CITY OF PLANTATION DEVELOPMENT REVIEW APPLICATION

8601 W. Sunrise Boulevard Conditional Use

**Planning, Zoning & Economic Development I
Memorandum**

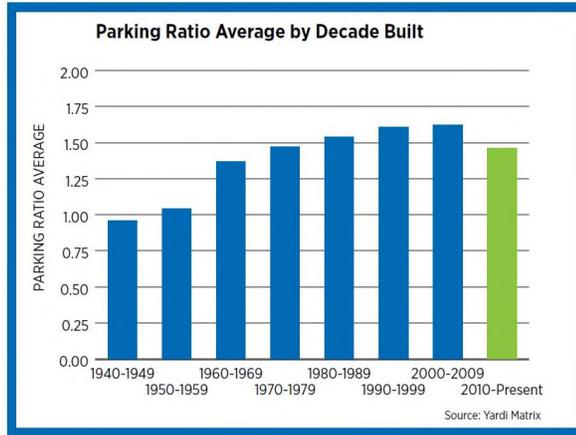
1. **From:** Section 27-641 which states that minimum setbacks need to be 1.5 times the height of the building.

To: Our dimensions vary throughout the project as detailed on page A2.1 of the submittal package.

Justification: The Code required setbacks would have a substantial impact on the amount of buildable space and park area the Applicant would be able to provide. With this waiver, a larger green area and a larger amenity area can be provided. Additionally, parking ratios, pedestrian walking paths, amenity areas, and circulation would also be negatively impacted if the Applicant was required to meet the Code.
